Study Group **WAGON USERS**

Proposed amendments to GCU Appendices 9 and 11: No. 9

Title:	Clarify "CT" marking in Appendix 11
Proposed amendment made by: RU / keeper / other body	SNCF
Proposed amendment concerns:	<input type="checkbox"/> Appendix 9 <input checked="" type="checkbox"/> Appendix 11
Proposer:	Geoffroy Maille, SNCF
Location, date:	Mainz, 24/3/2015
Concise description:	The "CT" sign, for wagons authorised to use the Cross-Channel Fixed Link (CCFL) to and from Great Britain, is no longer needed. This should be made clear in GCU Appendix 11.

Figure 1 For wagons accepted on ferries **to and from, and authorised to run in, Great Britain (NETWORK RAIL infrastructure)** ~~emprunter les~~

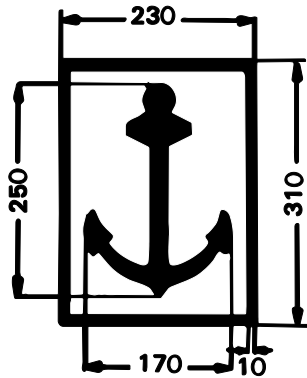
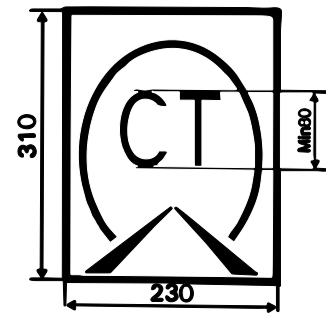
Figure 2 For wagons **authorised to use the Cross-Channel Fixed Link (CCFL) and run in Great Britain (NETWORK RAIL infrastructure)** ~~authorised to run through the Channel Tunnel~~

Figures 3a, 3b, 3c For wagons accepted on ferries and **authorised to use the Cross-Channel Fixed Link (CCFL) and run in Great Britain (NETWORK RAIL infrastructure)** ~~authorised to run through the Channel Tunnel~~

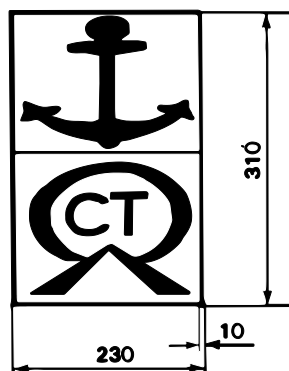
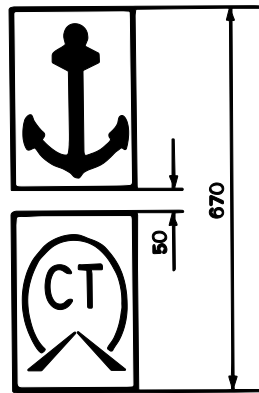
Figure 3a For wagons accepted on ferries

Figure 3b For wagons authorised to run through the Channel Tunnel
